Tolerance (Inches)	 Memory Protection Devices, Inc. 200 Broad Hollow Road, Farmingdale, New York 11735		
Decimal		Scale	Drawn By B.S.
$\pm .5$ (.020)			Approved By T.B.
Fractional	Title		
$\pm .8$ (.030)	CIGARETTE PLUG FOR 21 OR 22.2mm DIA. SOCKETS		
Angular	Date	Drawing Number	
$\pm 3^\circ$	02/17/17	APP-001

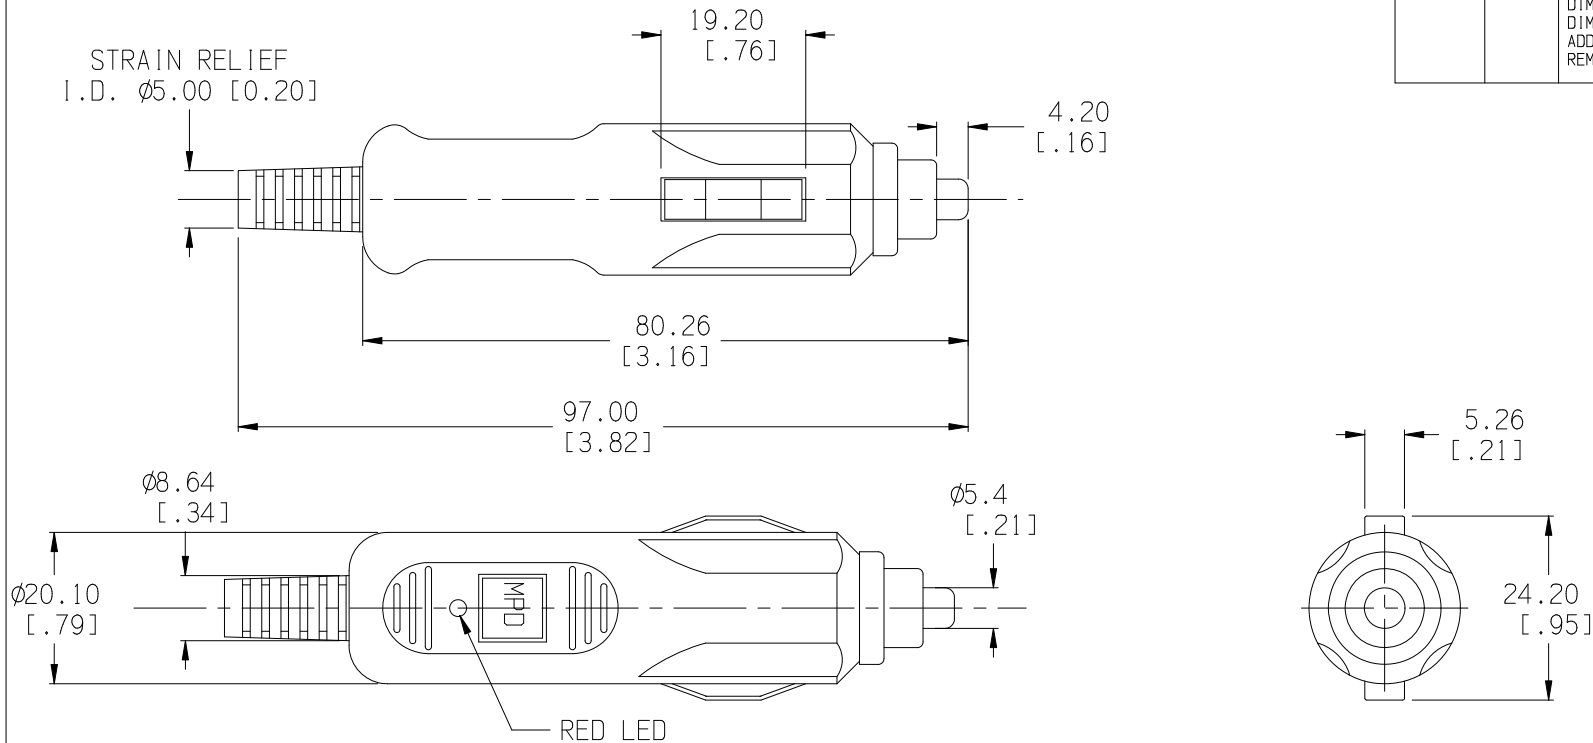
Date	SYM	REVISION RECORD	AUTH	DR.	CK.
2/27/09	E	FUSE SPEC. WAS 8AG S/O B/O TYPE	T.B.	B.S.	
08/28/14	F	UPDATED TO ROHS 2 COMPLIANT	T.B.	B.S.	
02/17/17	G	UPDATED SPECIFICATIONS DIM. 97.00 WAS 96.77 DIM. 20.10 WAS 20.07 DIM. 4.20 WAS 4.17 DIM. 24.20 WAS 24.38 ADDED STRAIN RELIEF DIM. REMOVED DIM. 3.25,5.18,10.49	T.B.	B.S.
